**SAN ANTONIO WATER SYSTEM  
Interdepartment Correspondence Sheet**

**Subject:** Zoning Case Z2021-10700106 (Hausman Rd Duplex)

**SUMMARY**

ZONING FILE: HAUSMAN RD DUPLEXES (FIGURE 1)  
ZONING CASE: Z2021-10700106  
MAP PAGE: 168, A2

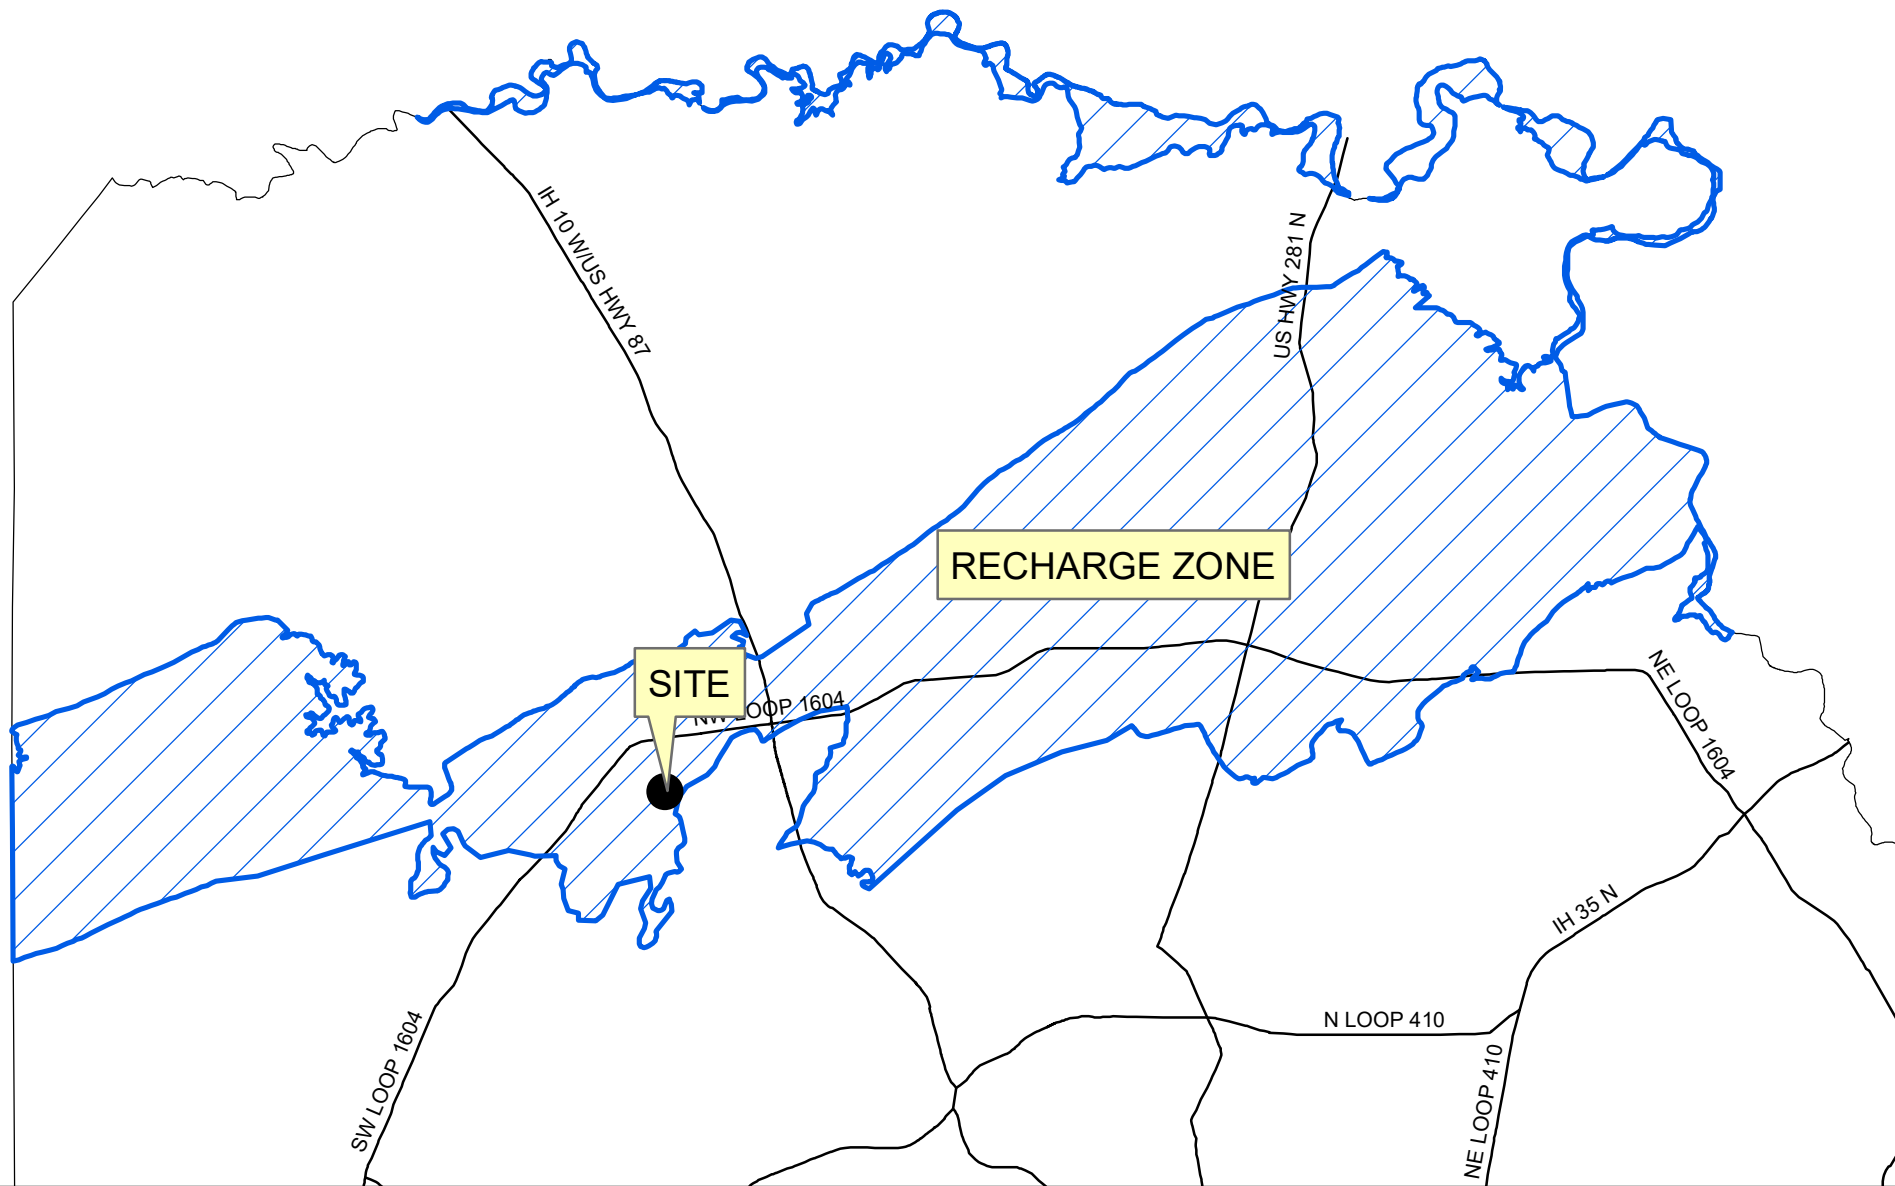
The subject property is in City Council District 8, approximately 150 feet east of Ridge Oak Parkway and Hausman Rd. intersection. The property lies within the Edwards Aquifer Recharge Zone (Figures 1 and 2).
